DEPARTMENT OF HIGHWAYS - ONTARIO		
MATERIALS & RESEARCH SECTION		
KAYLER (WILTON) CREEK AND HIGHWAY NO. 2		
ORIGINATED BY: KULMATICAS	DISTRICT NO. 8	DATE: SEPT. 21, 1961
DRAWN: F. CLARK	W.P. NO. 202-61	JOB NO. 61-F-87
CHECKED: <i>[Signature]</i>	SCALE	DRAWING NO.
APPROVED: <i>[Signature]</i>	AS SHOWN	61-F-87A

DEPARTMENT OF HIGHWAYS ONTARIO BRIDGE DIVISION			
<u>KAYLERS (WILTON) CREEK BRIDGE AT MORVEN</u> <u>4.1 MILES EAST OF NAPANEE</u>			
KING'S HIGHWAY No. 2		DIST. No. 8	
CO. LENNOX & ADDINGTON		CON. IV	
TWP. ERNESTOWN		LOT 4	
GENERAL PLAN			
APPROVED		SITE No.	
BRIDGE ENG-YEAR		W.P. No. 202-61	
DESIGN	J. S.	CHECK	S. S.
DRAWING	R. M. S.	CHECK	S. S.
DATE	DEC. 1926	RE-DESIGN	H. 20
CONTRACT		DRAWING No.	
No. 1		D 4973 - 1

D.H.C. FOUNDATION INVESTIGATION
REPORT.
W.J. 61-7-87 -- W.P. 202-61.

Proposed New Bridge - Hwy. #2 and
Wilton (Kayler) Creek - 4.5 Miles
E. of Napanee, Twp. of Ernestown,
County of Lennox and Addington,
W.J. 61-F-87 -- W.P.202-61 --Dist.#8

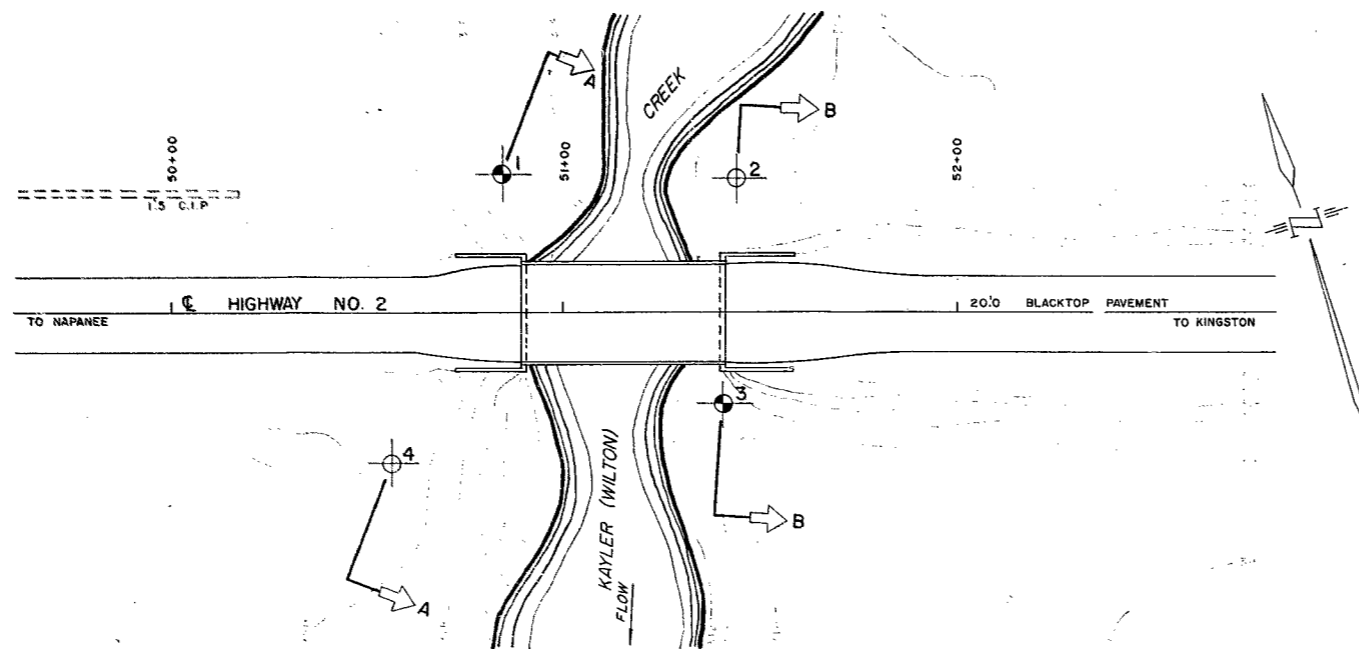
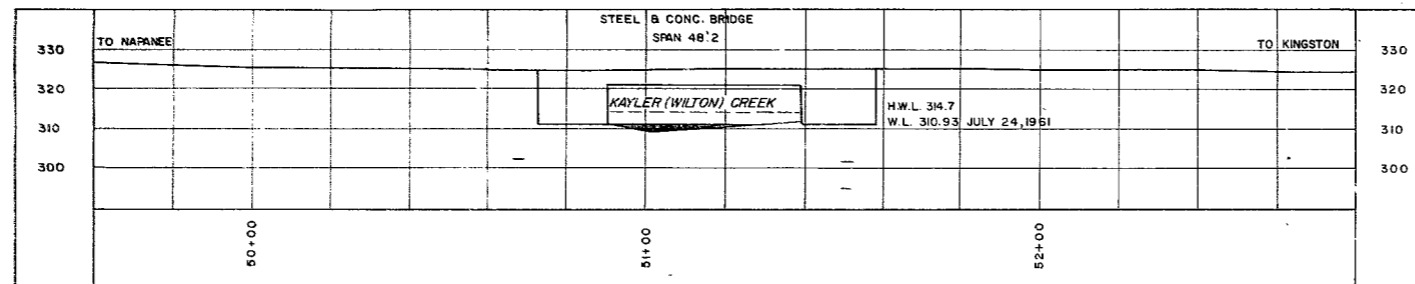
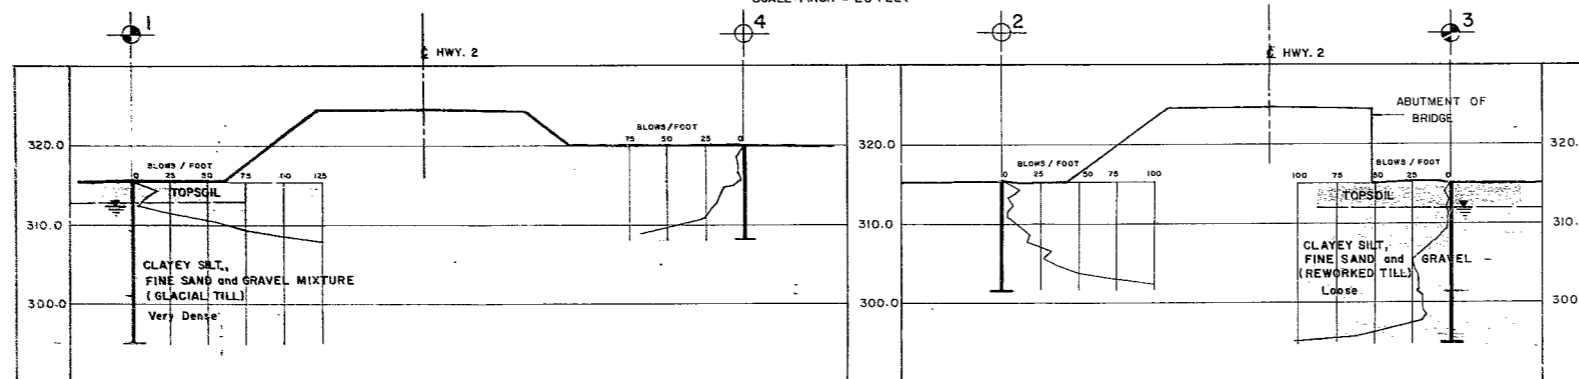
Note - 8' head of water
with basically granular
material - will piping
or quick condition exist?

- (1) We are of the opinion that 'quick' conditions will not occur during excavation or dewatering of the West abutment footing.
- (2) We suggest that the dewatering of all excavations be left entirely to the contractor. He should be allowed to bid on a scheme of his own choice.
- (3) We have reviewed General Plan D-4973-1 with regard to the bridge foundations, and are in accordance with your proposals.

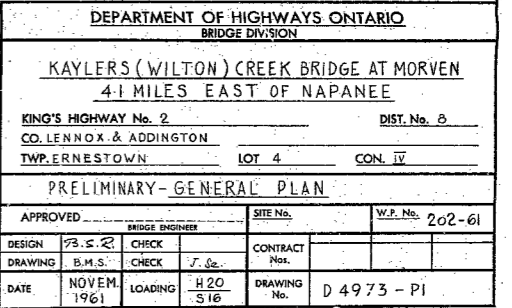
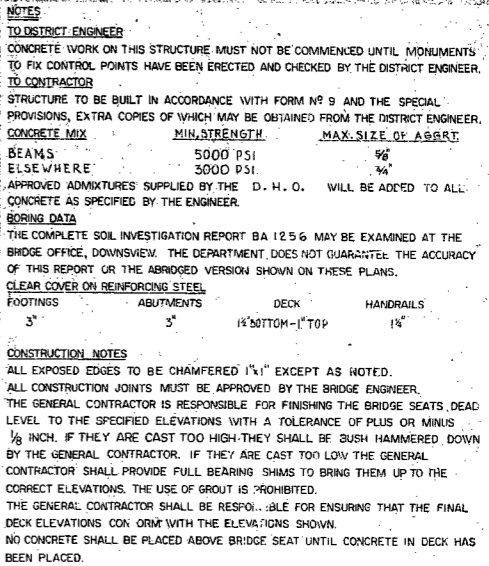
The designer has followed closely the recommendations of the foundation report (W.J. 61-F-87) with the exception that he has not indicated any sheet piling at the abutments. It is felt that the material is too dense to drive sheet piles at the west abutment.

Would you kindly give us your comments on
this proposal.
